Order No.: P-B-72.00/85

SUBJECT: Model 221.171/176/177/179/186

**Outside Door Handle Sticks in Pulled Position**

Figure 3 P-B-72.00/85

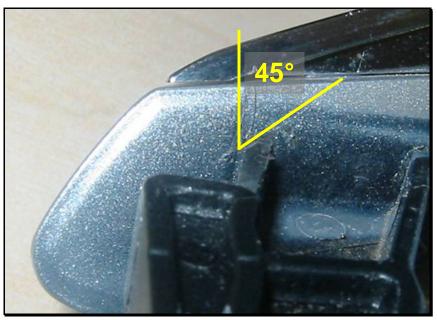
If you receive customer reports in the above model vehicles of the outside door handle sticking in the pulled out position on either the front or rear doors, the outside door handle may be contacting the door skin. Perform the procedure outlined below to resolve.

- Remove the outside door handle. Refer to WIS document AR72.10-P-2400SXS (front) or AR72.12-P-2410SX (rear).
- 2. Bevel the front rib of the outside door handle assembly (Figure 1 and 2) by approximately 45°.
- 3. Install the beveled outside door handle (Figure 3).
